FORM P2A: FINAL SIGN-OFF FOR MASTER DEVELOPMENT PLANS AND SITE PLANS - EPC

FINAL SIGN-OFF FOR MASTER DEVELOPMENT PLANS AND SITE PLANS – EPC

OFFICIAL NOTIFICATION OF DECISION

Project #2020-004457
SI-2021- 00651 - Site Plan-EPC
VA-2021-00145 - Variance-EPC

PERIMETER SCREEN WALL DETAIL WHICH ABUTS MAJOR PUBLIC OPEN SPACE
NTS—Walls shall comply with 3-4(N)(5)(b) Building Design and Standards

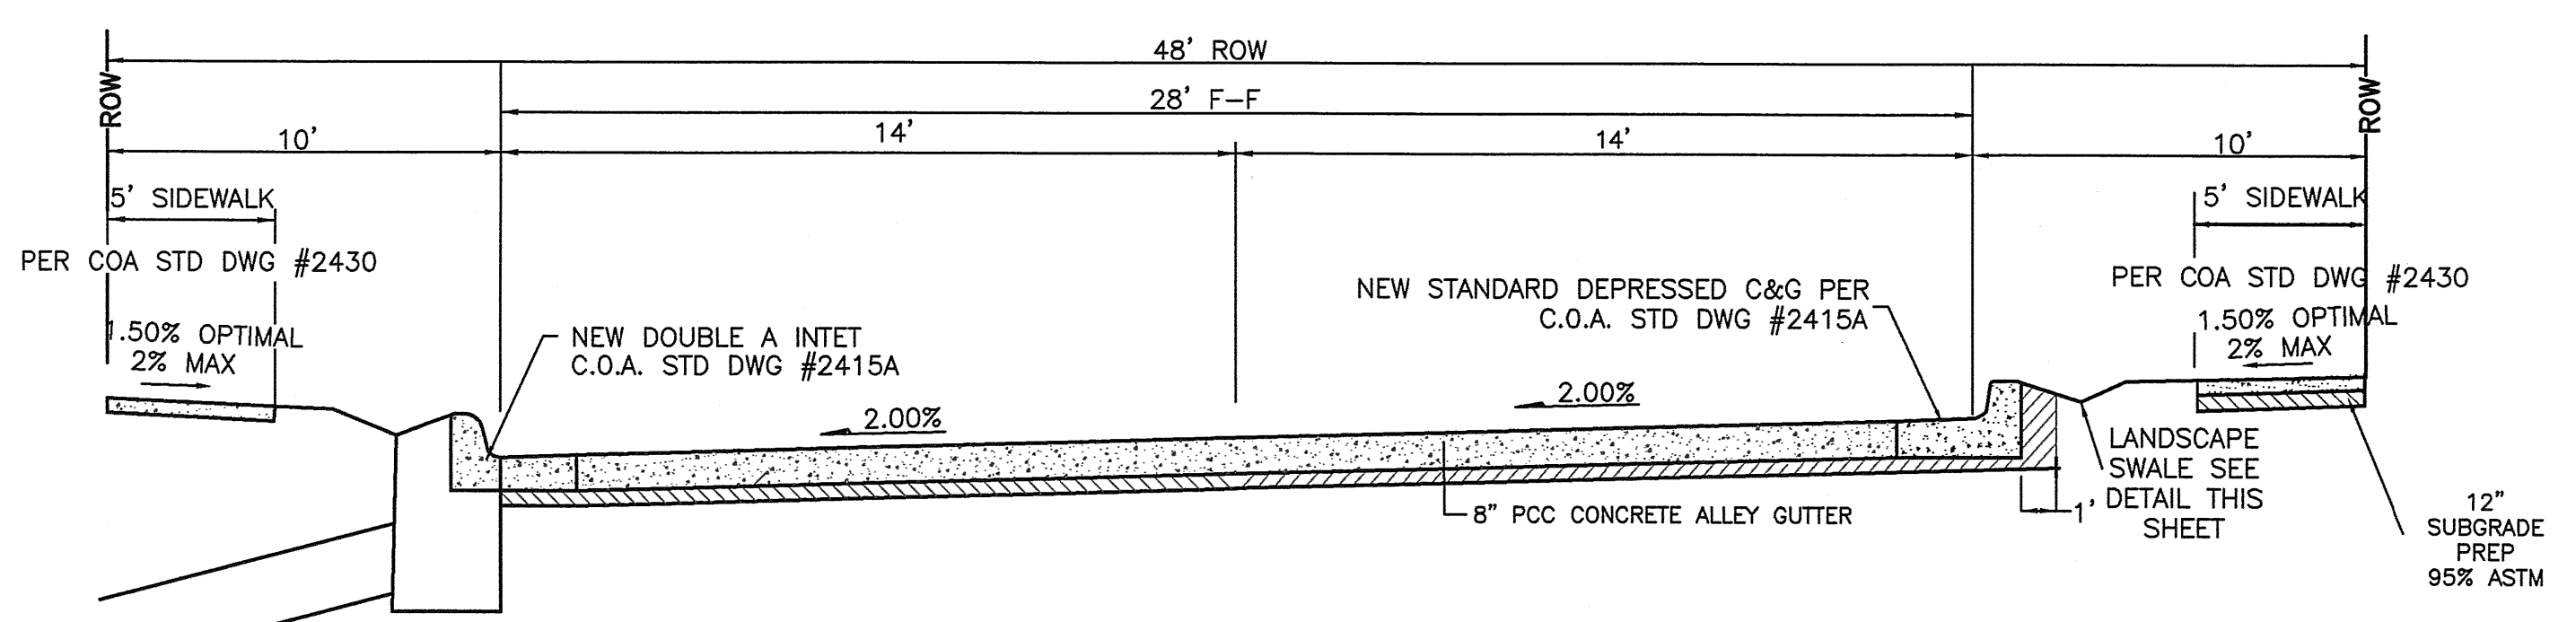
Detail for perimeter walls abutting MPOS shall be revised to correct conflicting heights. A keyed note reads “6-foot high screen wall”, but the dimension shows a maximum height of 3-feet. **corrected**
